CARTER WATKINS ASSOCIATES ARCHITECTS, INC.

DATE: August 28, 2023
TO: **ALL BIDDERS**
RE: **Jackson County Animal Shelter**

ADDENDUM #1

2 EXISTING SLAB @ THICKENED SLAB WITH STEM WALL

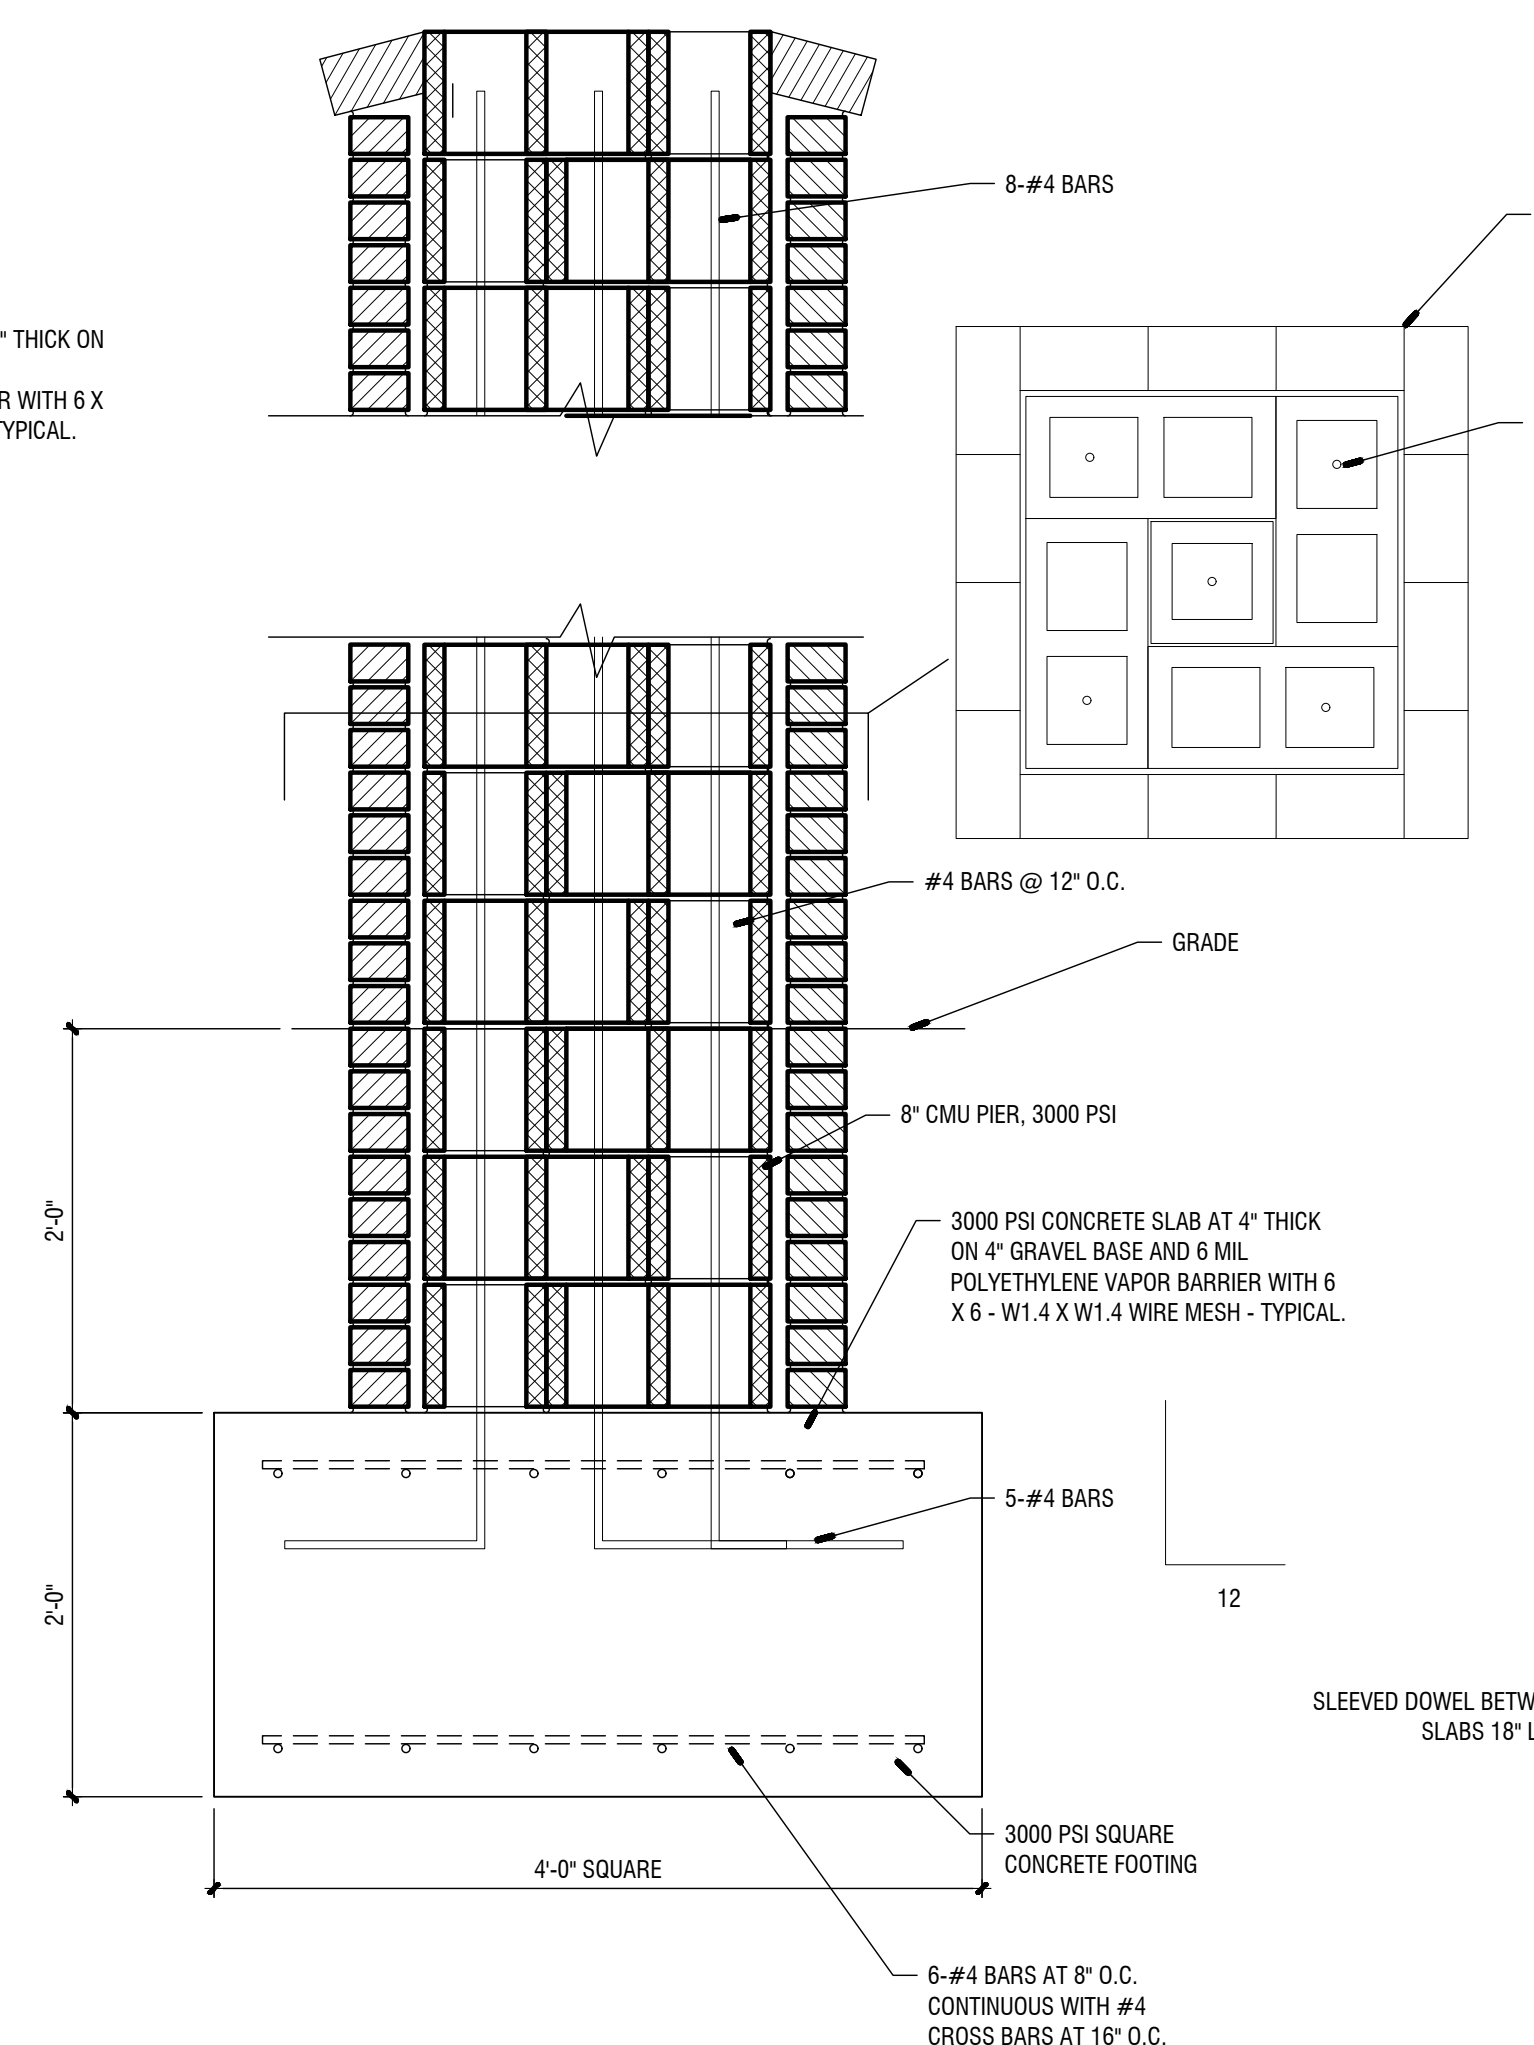
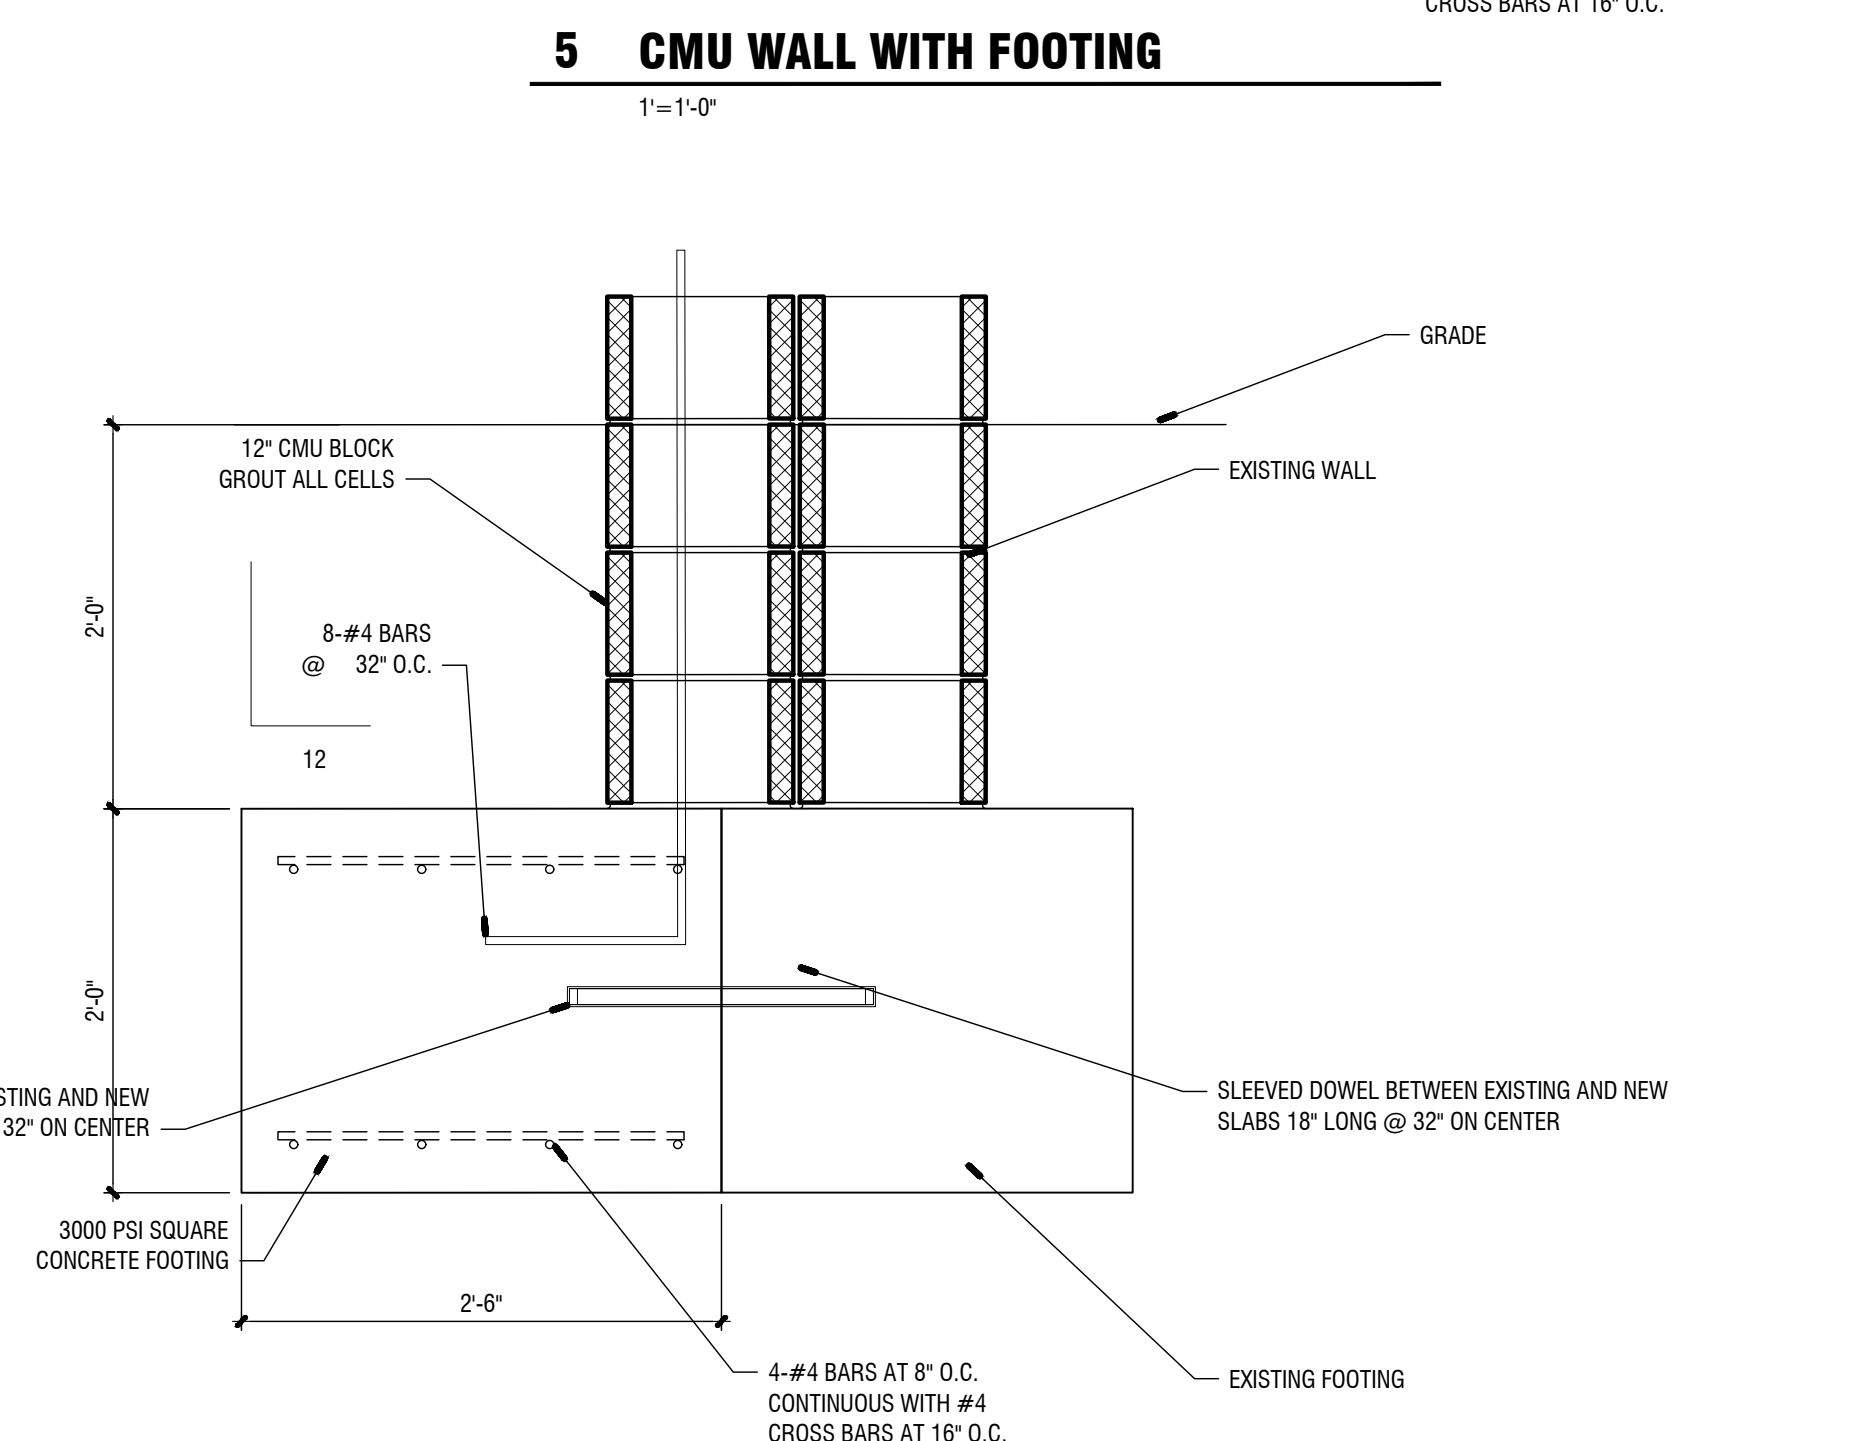
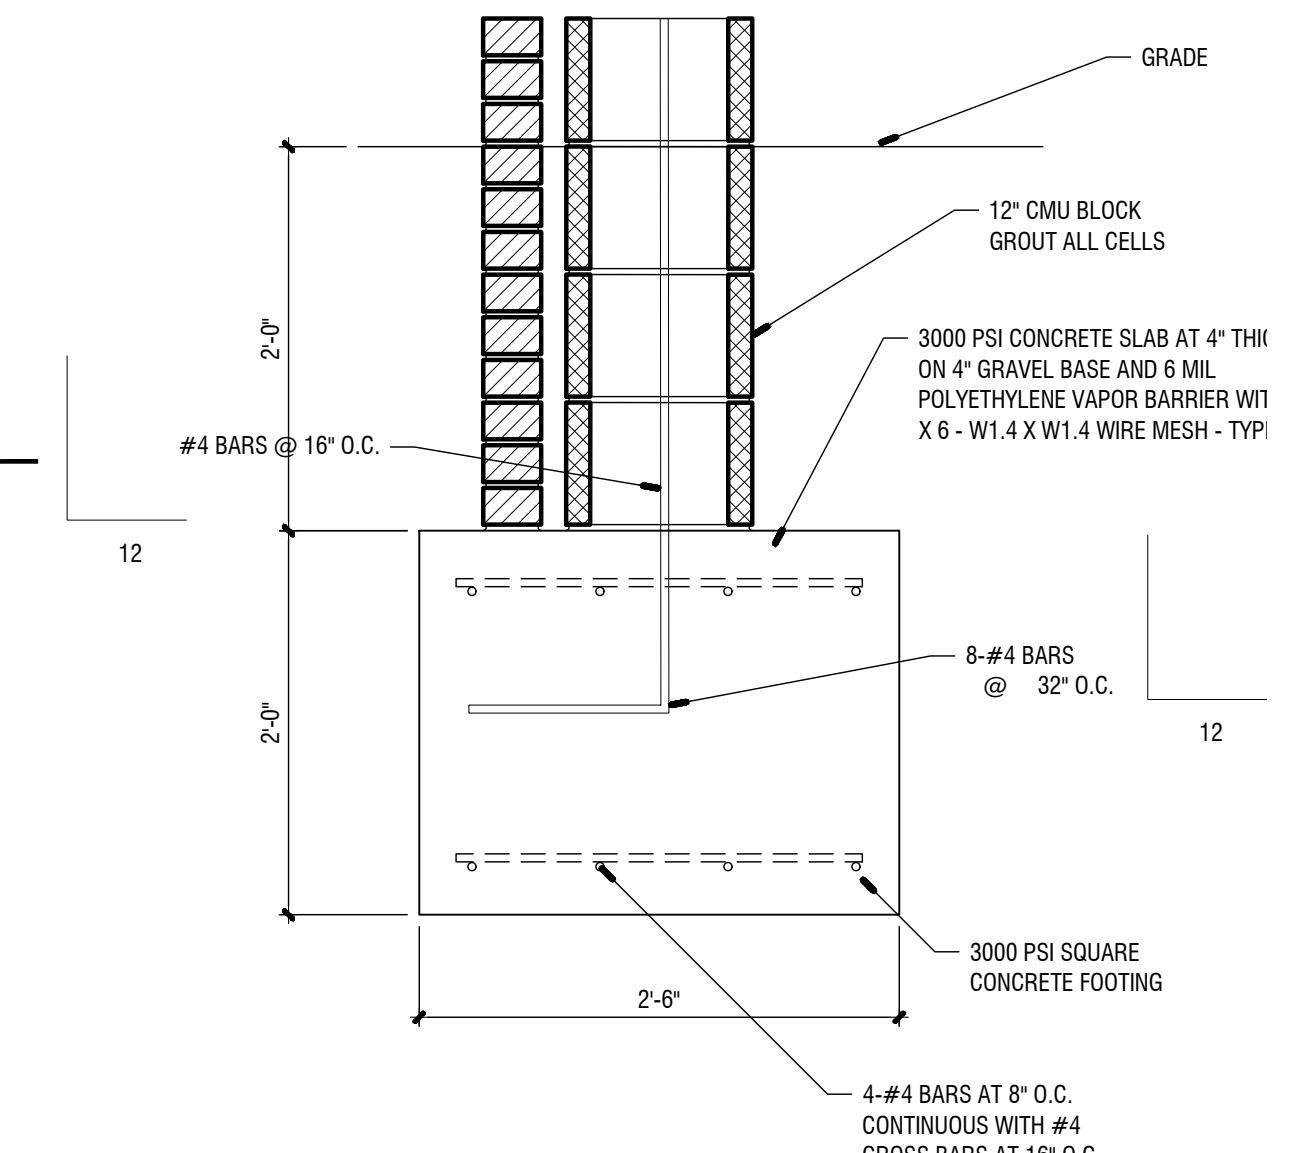
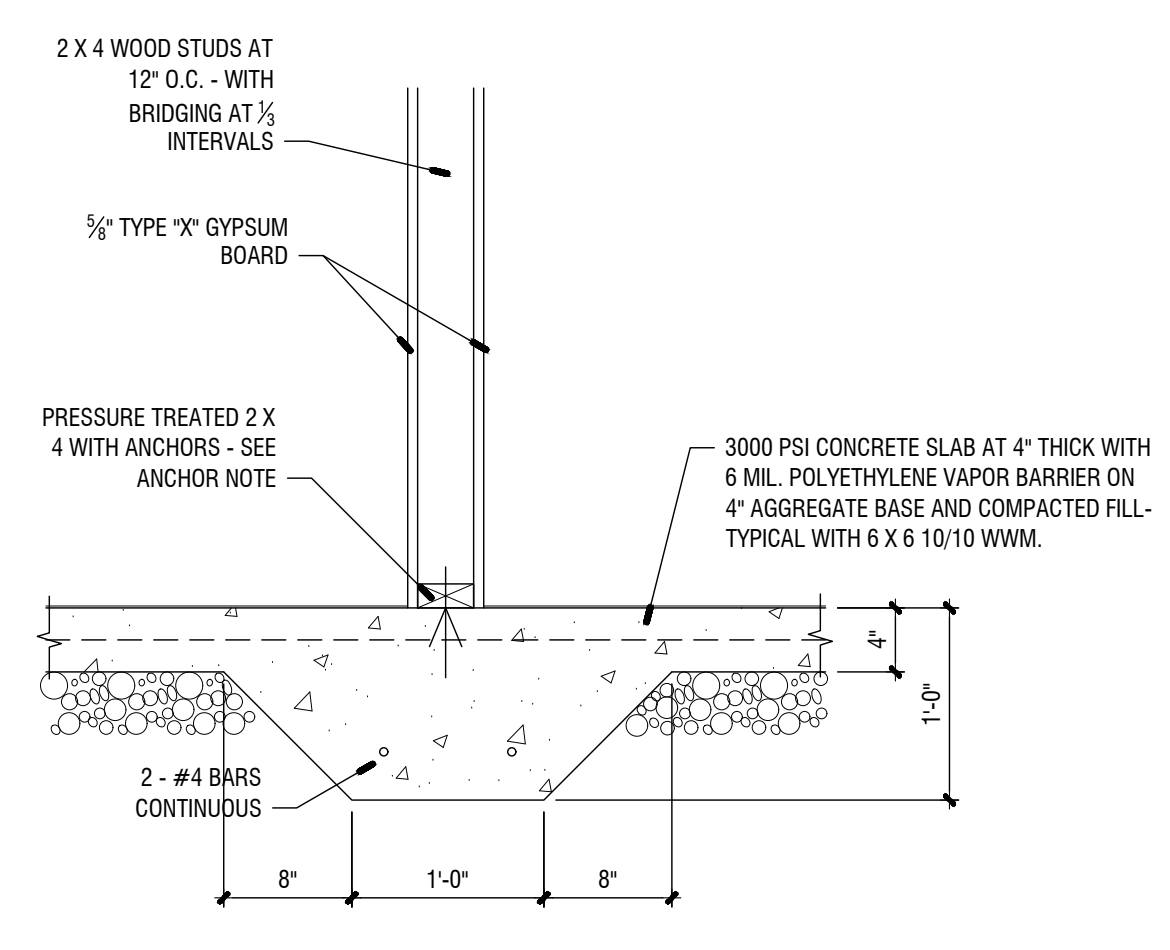
3. See the attached revised E-3 sheet.
4. See the attached revised S-001 & S-002 drawings.
5. See supplemental sheet AA-01 with notes for Alternate Add #1 Walk-in Freezer/Cooler.
-New cooler/freezer manufacturer to be Southeast Cooler or as equal.

| REVISIONS | | | CONSULTANTS | | |
|-----------|---------|-------------------------|-------------|------|---------|
| 1 | 8.28.23 | REVISED FOUNDATION DWGS | | | |

SHEET TITLE:
ALTERNATE ADD #1 NEW WALK IN
COOLER/ FREEZER
 PRINTED:

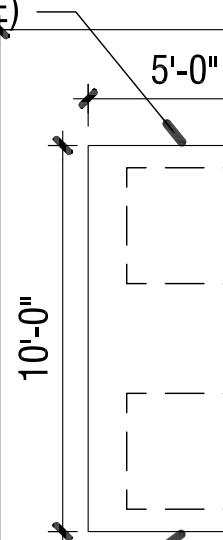
VERIFY REQUIRED CONC. PAD SIZE WITH
MANUFACTURE & UNIT SIZES.
(WALL HUNG UNITS ARE ACCEPTABLE IF
POSSIBLE)

EXISTING COOLER/FREEZER PAD TO
REMAIN AND BE REUSED.
-MAXIMIZE COOLER/FREEZER AREA
TO EXISTING PAD
-FIELD VERIFY ALL DIMENSIONS.
